PROJECT
ISSAQUAH GATEWAY

I-90 Green Edge Views with New Parking Lot - Proposed Revision

ATTACHMENT 4 SDP15-00002 GATEWAY APARTMENTS

Public Comments to Proposed Revision to Parking along I-90

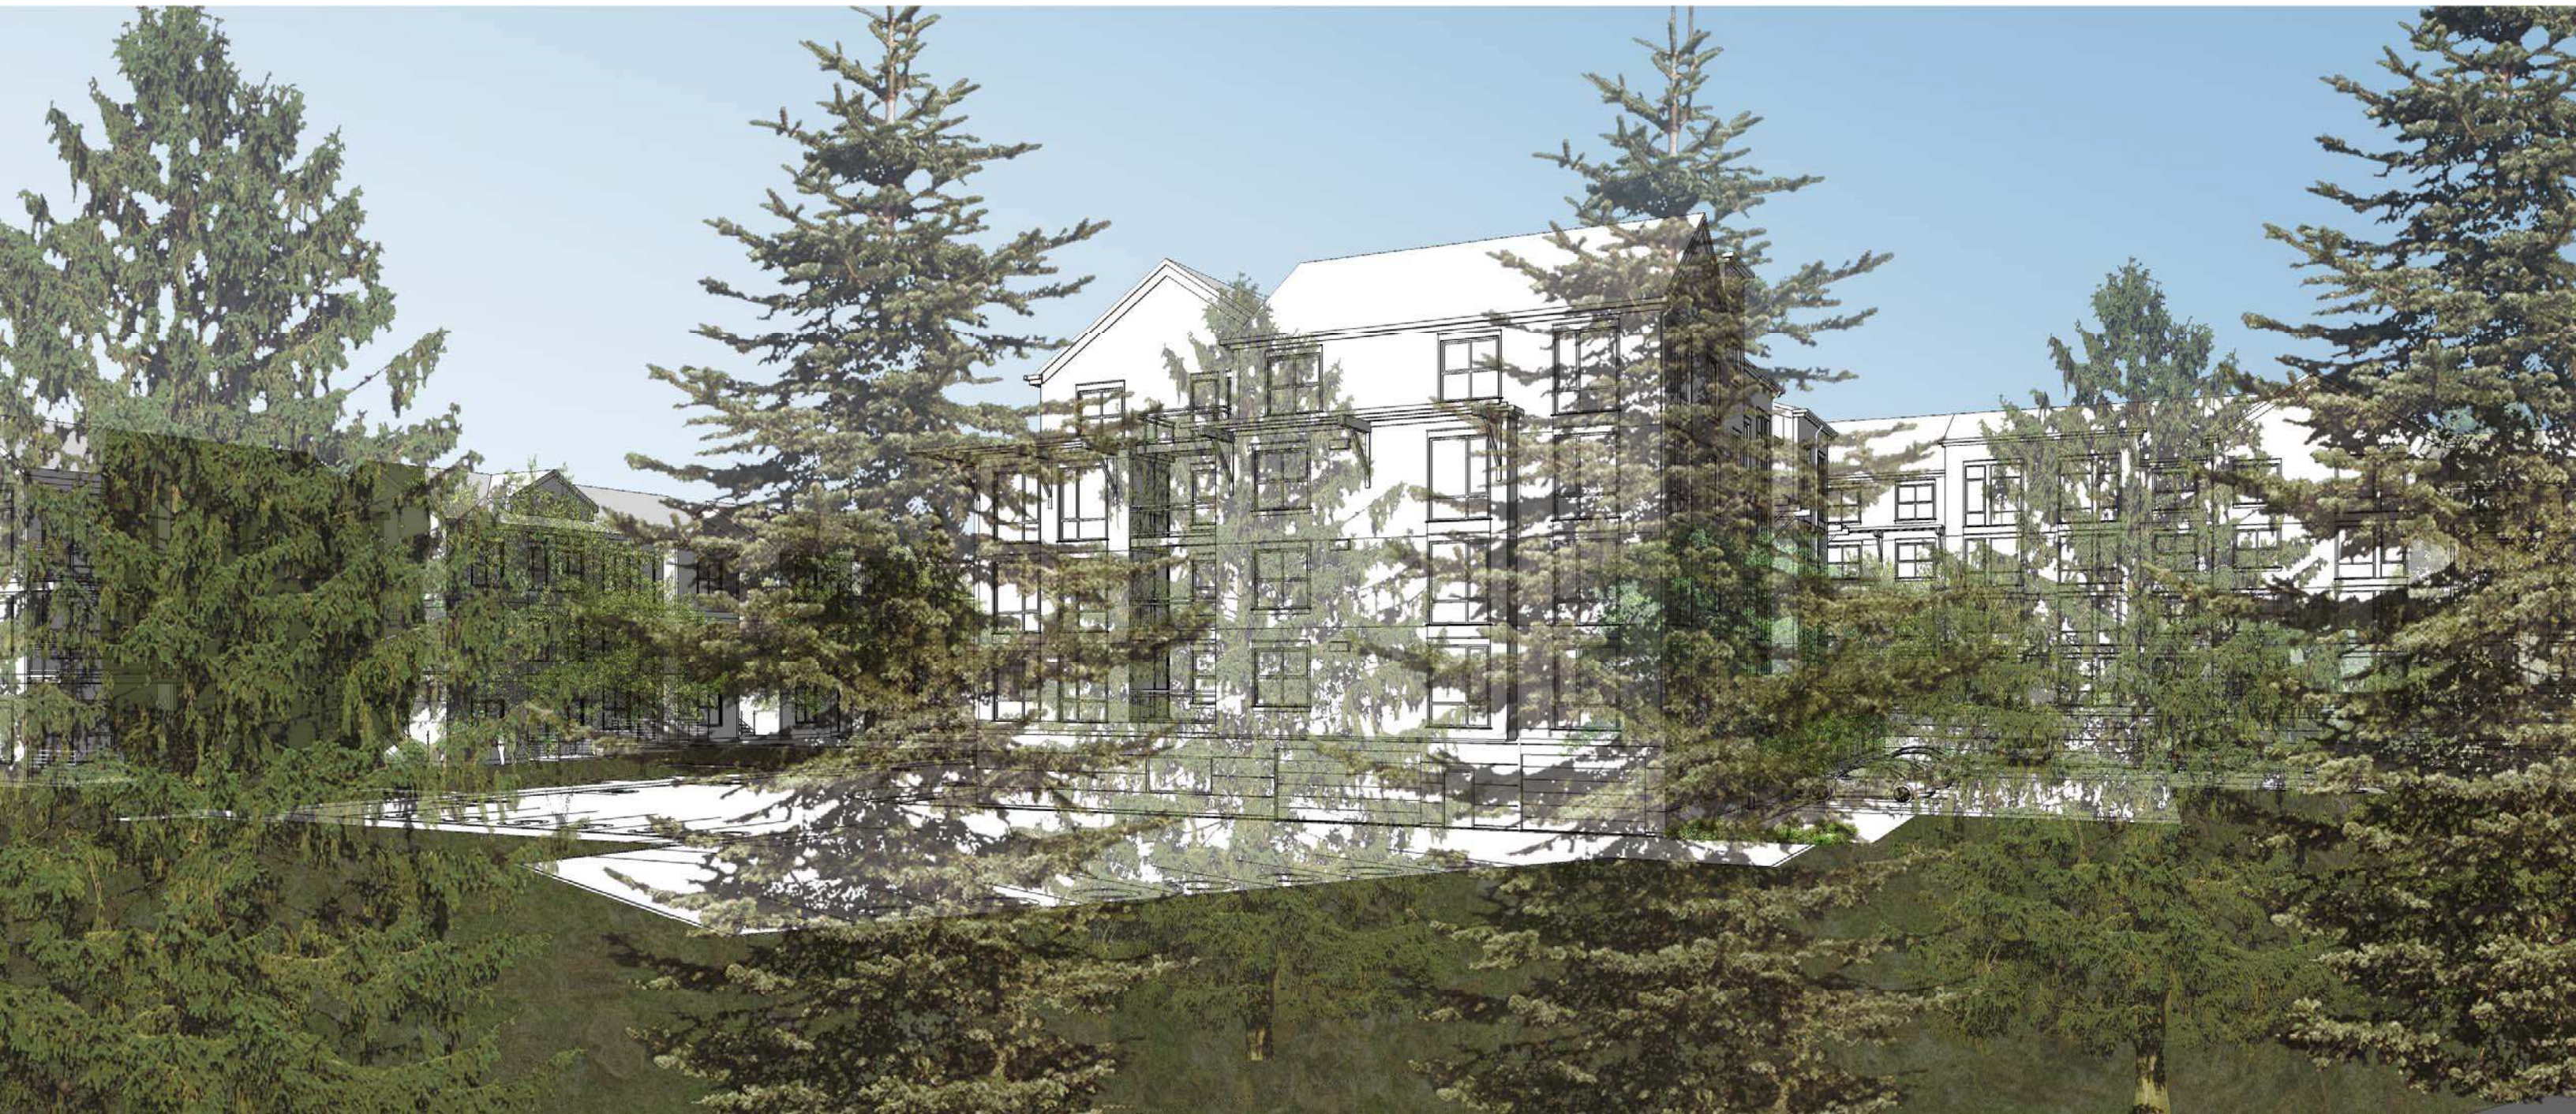
I am perplexed that more surface parking would be allowed after the plan was approved. The CIP has a large base in reducing surface parking, often citing the expansive surface lots as a huge negative, yet after a plan is agreed upon the City is looking at allowing more surface parking?

It is unclear why this is needed, and it is unclear how this is an improvement given the overall context of the CIP.

Yes, it all may be within the standards of the Central Issaquah Plan but SEPA still controls, and impacts to critical area buffer requires that the impacts first be shown that they cannot be avoided. Where is this conversation? Next the impacts need to be shown to be minimized. Where is this conversation? Finally, if there is no other alternative, which there clearly is, the impacts can be mitigated.

Please do not agree to this change to surface parking. See further language below from the CIP and the CIDDS.

1. So it does not have to be posted on the Active project list either?
2. What is the impact on storm water run off quantity with this added parking surface and reduction in buffers?
3. Will you send me a copy of the revised storm water runoff study for this and the added water for the artisan spring called out in the SEPA Addem.? There currently is still no storm water study posted on the active project list.
4. Also when can one expect to see an updated traffic study? With the SEPA Addem and added construction traffic would like to see a copy of the that to see how decisions were made and what is to come with Newport Way.

To clarify, this was determined to be a minor change or Level 0 and a Level 0 permit does not require public notice.

Mary,
As the Staff Memo to the Development Commission stated, this minor revision is a Level 0 review and we made the determination that this did not warrant public notice.
